ADDENDUM NO.: 4.0

DATE OF ADDENDUM: November 4, 2014

**Founders Hall Renovations for Allied Health and Nursing  
Naugatuck Valley Community College, Waterbury, Connecticut  
BI – CTC – 442 – CMR**

DATE	11/3/2014
COPYRIGHT ©	Moser Pilon Nelson Architects
SCALE:	NONE
SKETCH NO.	AD4-SK-SE.2-1

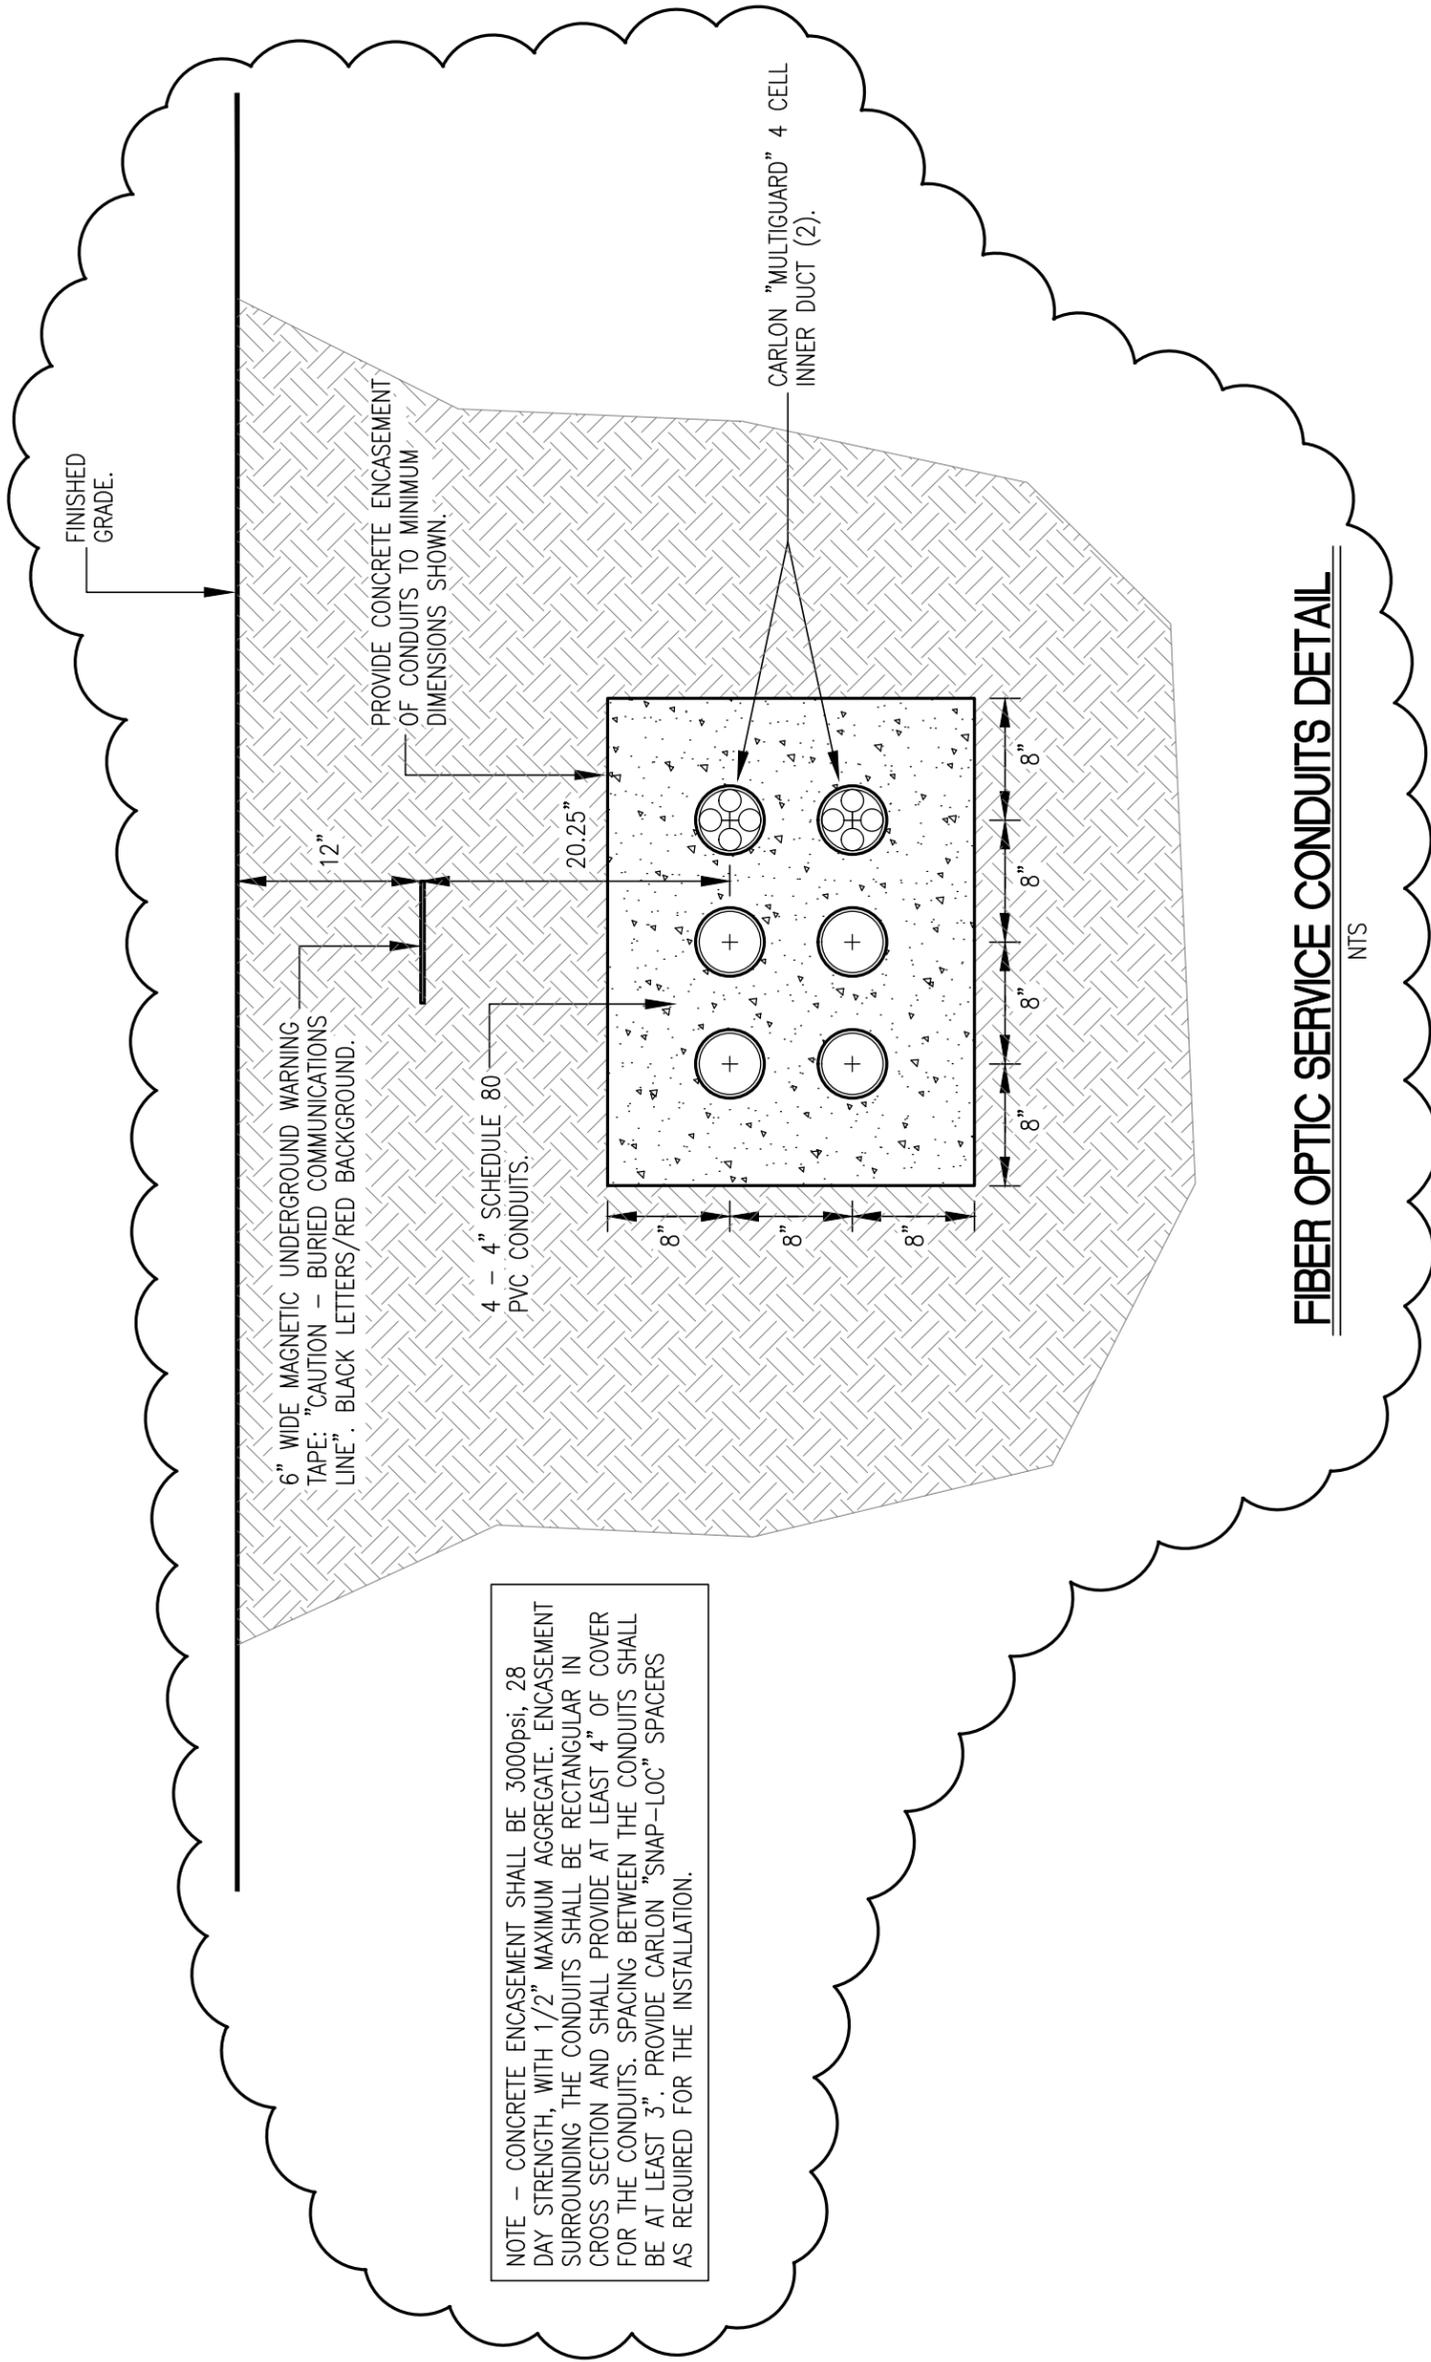
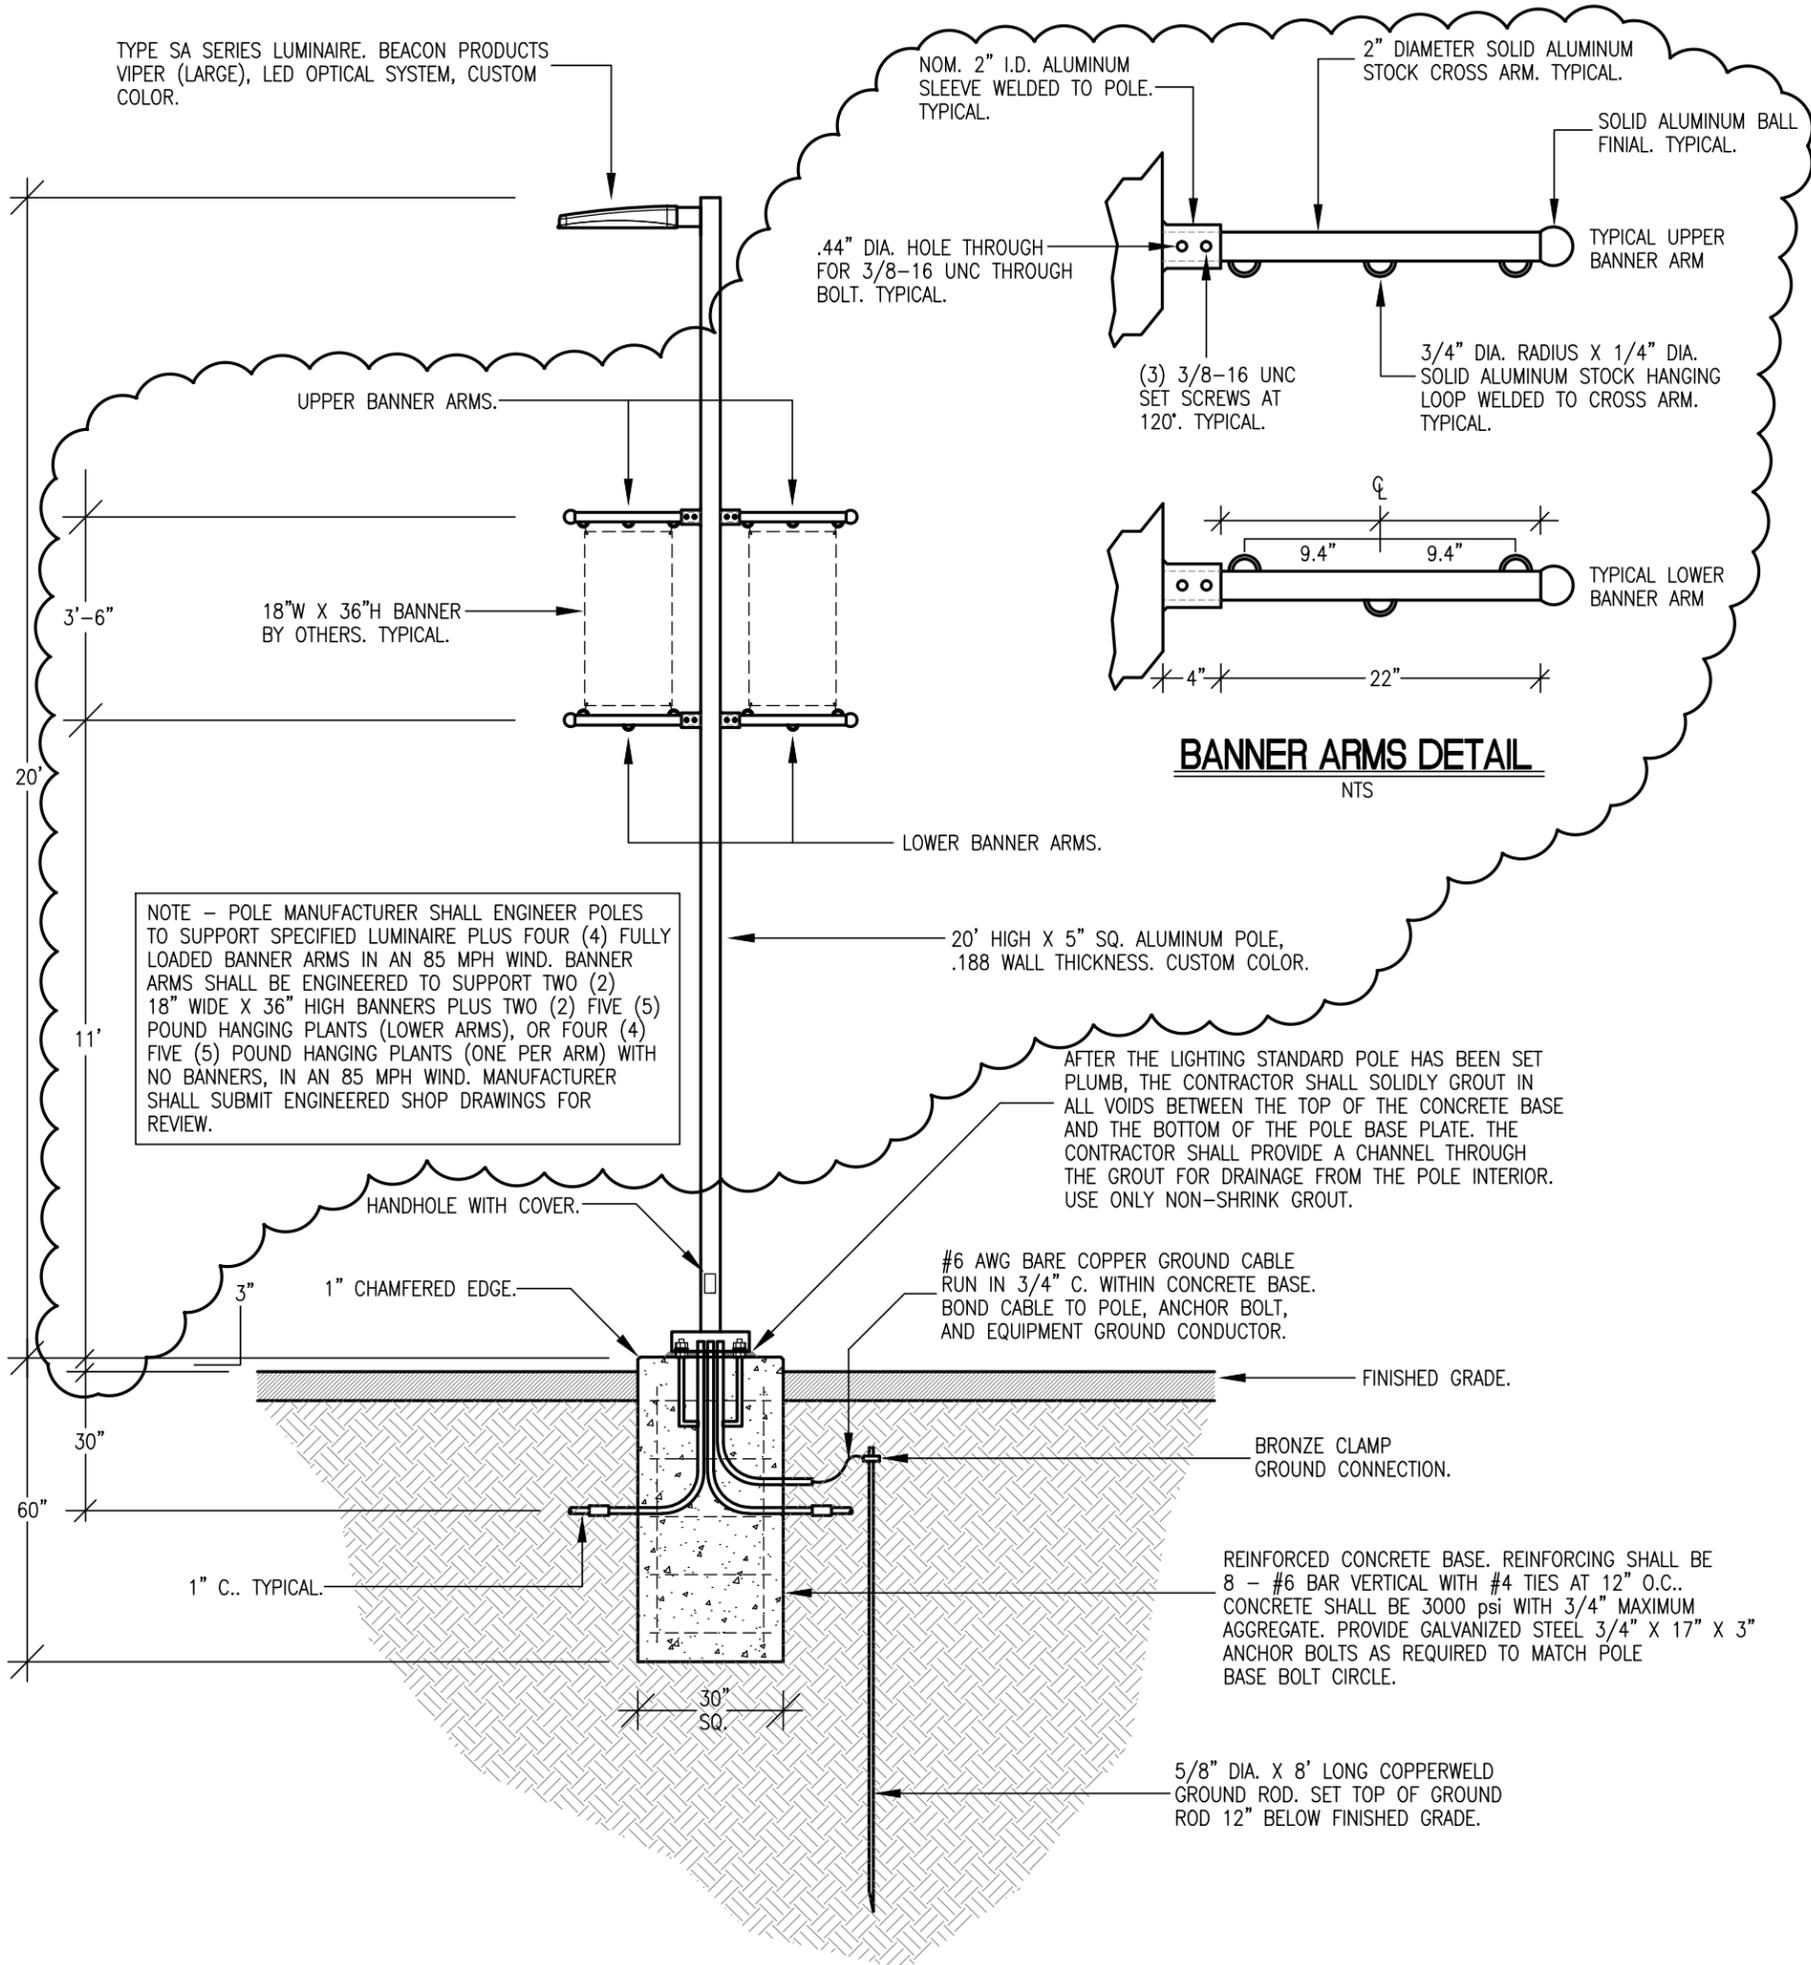
- a. **REVISE** fiber optic service conduits detail as shown by attached sketch AD4-SK-SE.2-1.
- b. **REVISE** site lighting standards SA3 and SA4 as shown by attached sketch AD4-SK-SE.2-2.
